September 29, 2025 – 7504 McLeans Road

Re: Site Alteration Permit Application
7504 McLean Road E, Puslinch
Gagandeep Dhinsa

Grand River Conservation Authority (GRCA) staff have reviewed the above-noted Site Alteration Permit Application to develop the property with a warehouse and transportation terminal.

RE: 7504 McLean Rd. E. - 2nd Submission Ecology Comments

Drawing C1.1: Original Conditions Plan

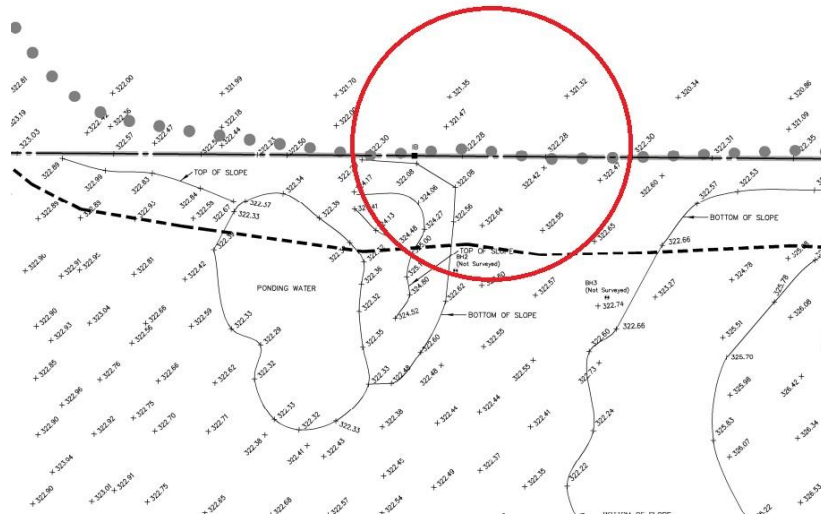
The Regulatory flood elevation (RFE) at this property is 322.3 m (CGVD28). We understand that that the floodplain and the GRCA regulated area are added on the site plan. However, based on our review of the survey, the floodplain still appears to extend onto the property in several locations. Some elevations along the west boundary of the property (e.g., 322.08 m) are below the regulatory floodplain line. Therefore, it is unclear whether the floodplain elevation has been accurately delineated on-site, and whether the proposed development activity is appropriately setback from the floodplain.

Please provide clarification regarding the extent of the floodplain in the area shown above. Based on the current delineation, additional survey points may be required and should be shown on the plans. Please kindly review and revise as necessary.
